EL18-053 - In the Matter of the Application of Deuel Harvest Wind Energy LLC for a Permit of a Wind Energy Facility and a 345-kV Transmission Line in Deuel County

The Deuel Harvest PUC application, like the county application, is full of omissions and vagueness. As an example, I submit a markup of the pre-construction wind turbine noise analysis. I do believe it will not pass peer review. Further, I do not believe this application meets the PUC's applicant responsibilities (attached).

APPENDIX D - PRE-CONSTRUCTION WIND TURBINE NOISE ANALYSIS

Pre-Construction Wind Turbine Noise Analysis

Figure 1-1. General Location of the Proposed Deuel Harvest North Wind Farm

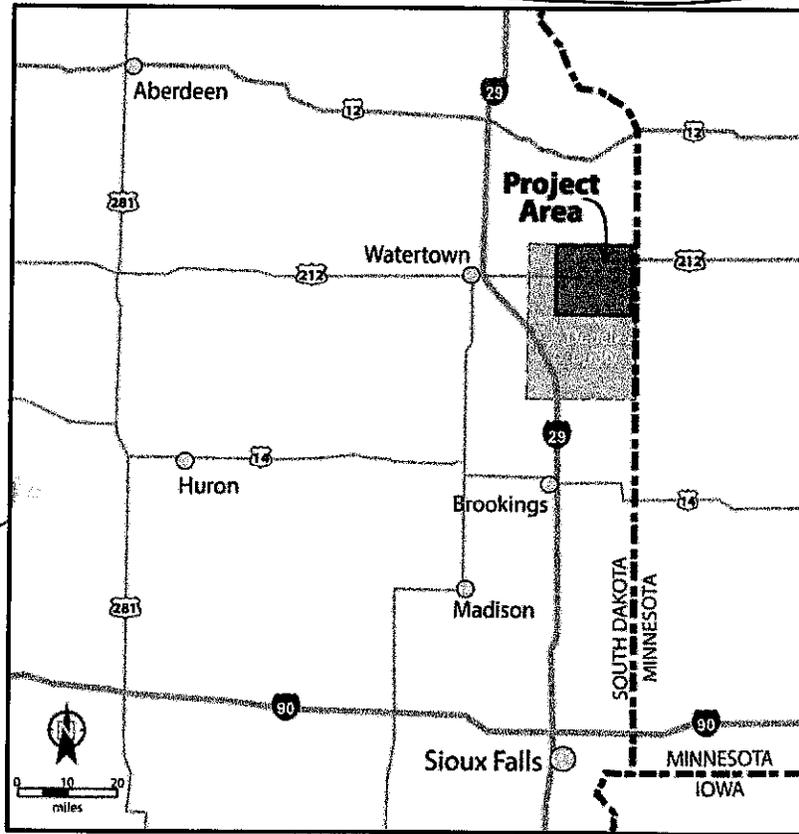
Big Deal
Old written
by people who profited
from wind contracts
